PD Modification Application: MM 24-0674

Hillsborough
County Florida

Development Services Department

AGENCY REVIEW COMMENT SHEET

2.5 Proposed Site Plan (partial provided below for size and orientation purposes. See Section 8.2 for full site plan)

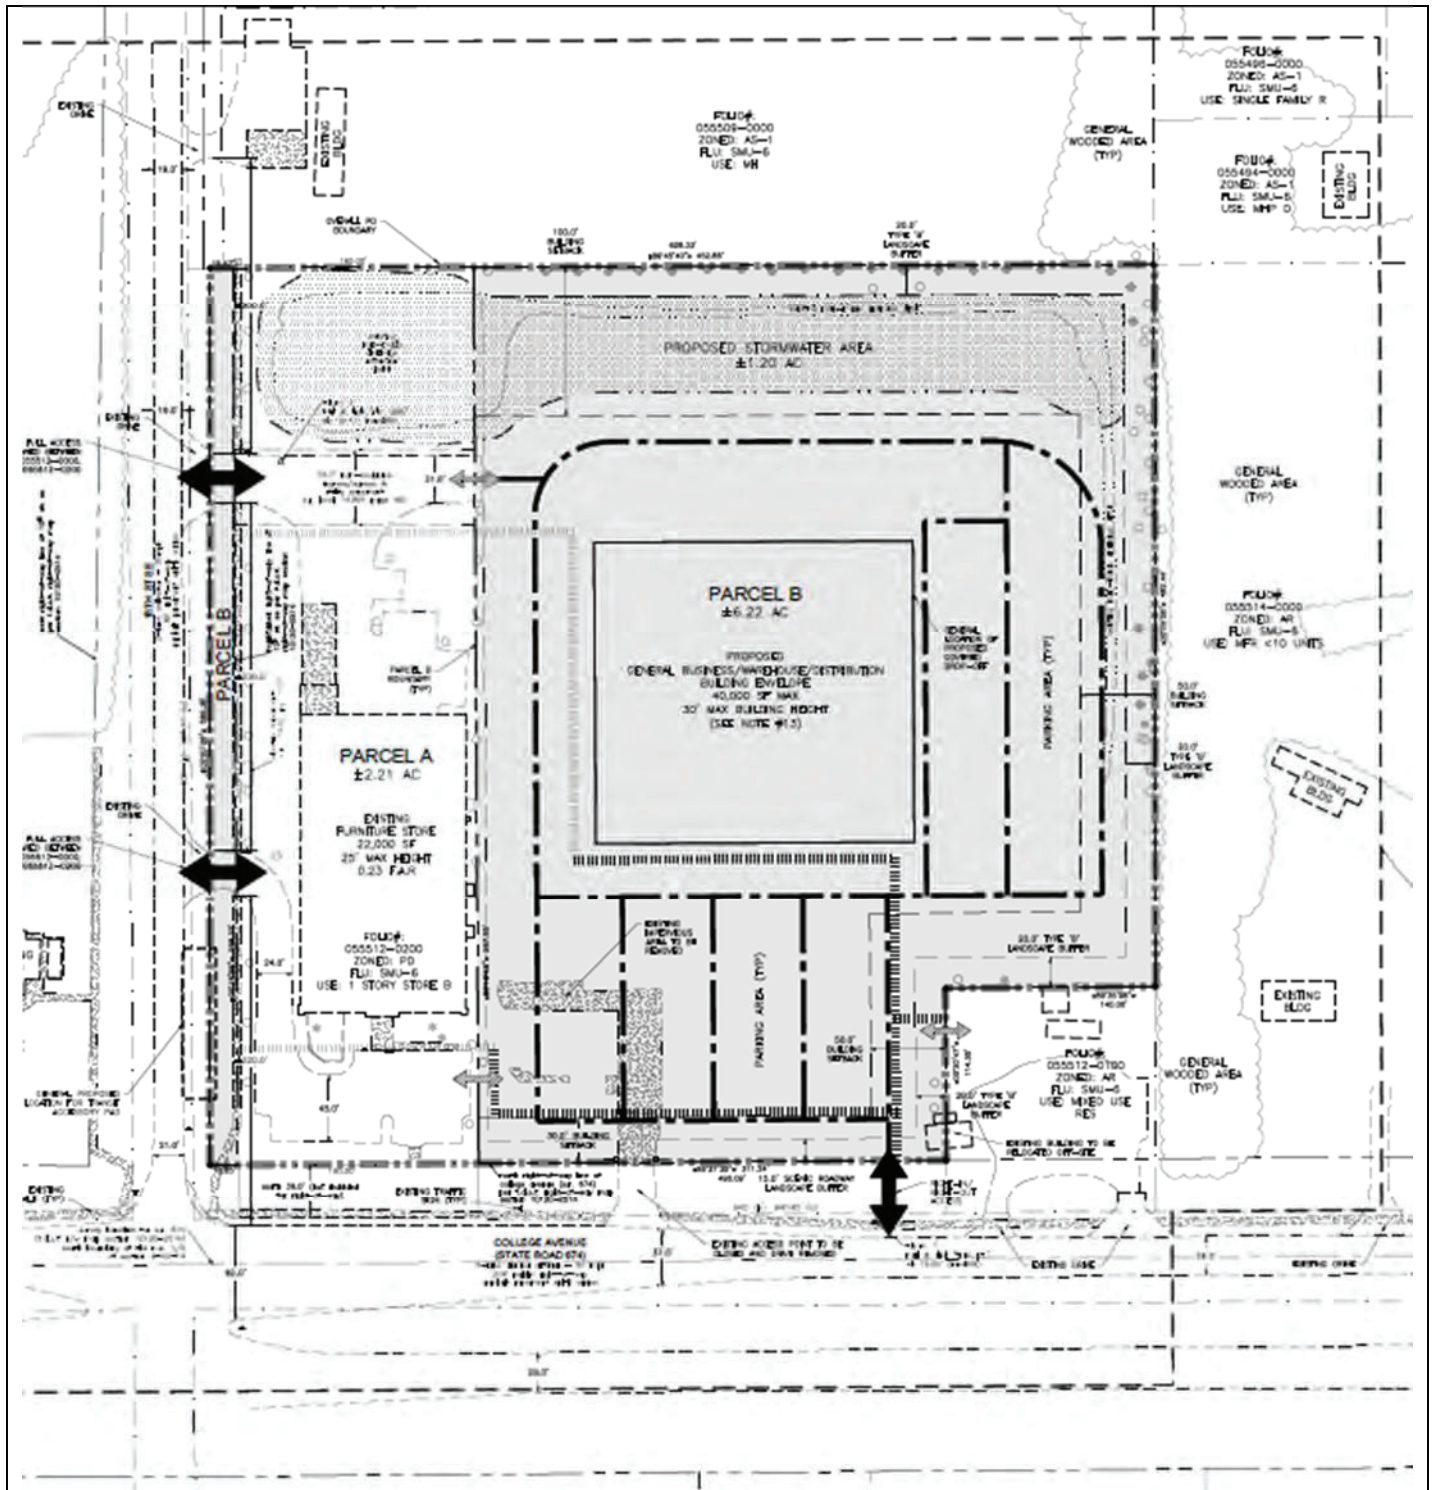
1. Revise the Label "Proposed General Business/Warehouse/Distribution Building Envelope" to Proposed Retail (Shopper's Goods)/Warehouse/Distribution Building Envelope".
2. Revise the Label "General Proposed Location for Transit Accessory Pad" to "General Proposed Location for Transit Facilities – See Conditions of Approval".
3. Revise maximum FAR from 0.27 to 0.17.

- Prior to PD Site Plan Certification, the developer shall revise the PD site plan to:
 - Revise the Label “Proposed General Business/Warehouse/Distribution Building Envelope” to Proposed Retail Shopper’s Goods/Warehouse/Distribution Building Envelope”.
 - Revise the Label “General Proposed Location for Transit Accessory Pad” to “General Proposed Location for Transit Facilities – See Conditions of Approval”.
